# Service Bulletin

Bulletin No.: 06-02-35-002

**Subject:** Diagnostic Trouble Code (DTC) C0710 Steering Wheel Position Sensor (SWPS) Signal, Service Stability System Message on Driver Information Center (DIC) (Inspect and Secure Wires in SWPS Connector)

**Models:** 2004-2006 Cadillac XLR  
2005-2006 Chevrolet Corvette  
with Steering Wheel – Tilt, Telescoping (RPO N37)

1714896

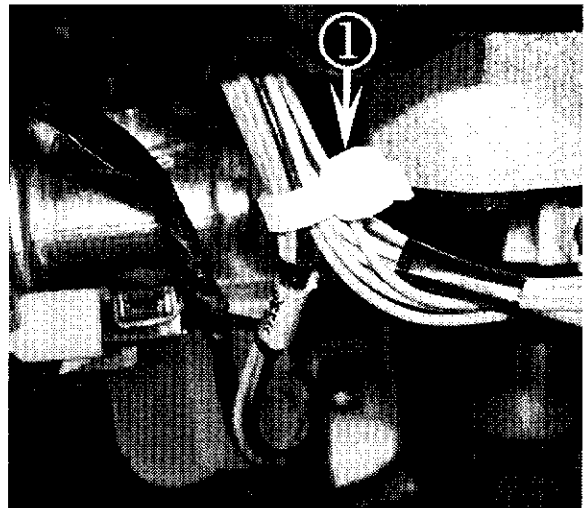
The most likely cause of a DTC C0710 on a vehicle equipped with telescoping/tilt steering wheel is high resistance in SWPS connector C202. Fretting terminal corrosion maybe present in the SWPS connector due to the telescoping motion of the steering column. When the steering column is telescoped in and out, the female terminals within the SWPS connector may move on the male terminals of the SWPS. This movement between the terminals may cause a high resistance condition in the SWPS connector.

1. Remove the driver's side close out panel.
  - Cadillac XLR — Refer to Closeout/Insulator Panel Replacement - Left (SI Document ID 1207847)
  - Chevrolet Corvette — Refer to Closeout/Insulator Panel Replacement - Instrument Panel (I/P) Lower (SI Document ID 1495116)
2. On XLR models only, locate and remove the plastic strap (1) on the steering column harness that retains the three wiring harnesses. Discard this strap.
3. Disconnect the SWPS connector C202 located on the lower center of the steering column.

1743934

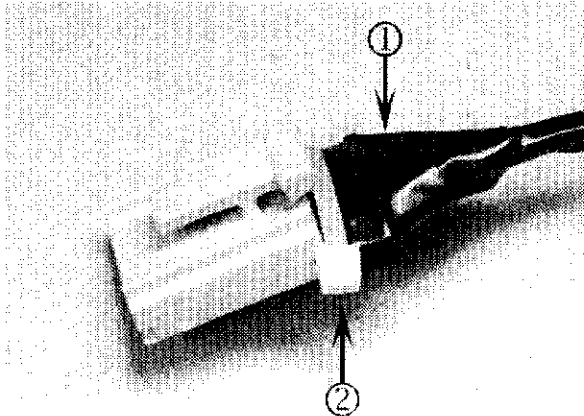
- Failure to properly tape the wires in the connector may result in additional concerns.
- Failure to use a small plastic strap 2.5-3.5 mm (0.10-0.14 in) in width may prevent the SWPS connector from properly seating, resulting in additional SWPS DTCs.
- Failure to position the plastic strap in the connector notch shown below may result in the strap becoming loose and allowing the terminal to move within the connector.

- Using electrical tape (1), tape from the plastic strap up the wires a minimum of 2.5 cm (1 in).
- Install a small plastic strap (2) 2.5-3.5 mm (0.10-0.14 in) wide around the SWPS sensor connector so that it retains the wires to the connector as shown.

**Important:** Install and remove the SWPS connector a minimum of three times to remove any possible terminal corrosion.

- Reinstall the SWPS connector.
- Reinstall the close out panel.
  - Cadillac XLR — Refer to Closeout/Insulator Panel Replacement - Left (SI Document ID 1207847)
  - Chevrolet Corvette — Refer to Closeout/Insulator Panel Replacement - Instrument Panel (I/P) Lower (SI Document ID 1495116)
- Clear the DTC with a scan tool and road test the vehicle.
- If DTC C0710 resets during the road test refer to:
  - Cadillac XLR — DTC C0710 (SI Document ID 1399468)
  - Chevrolet Corvette — DTC C0710 (SI Document ID 1460425)
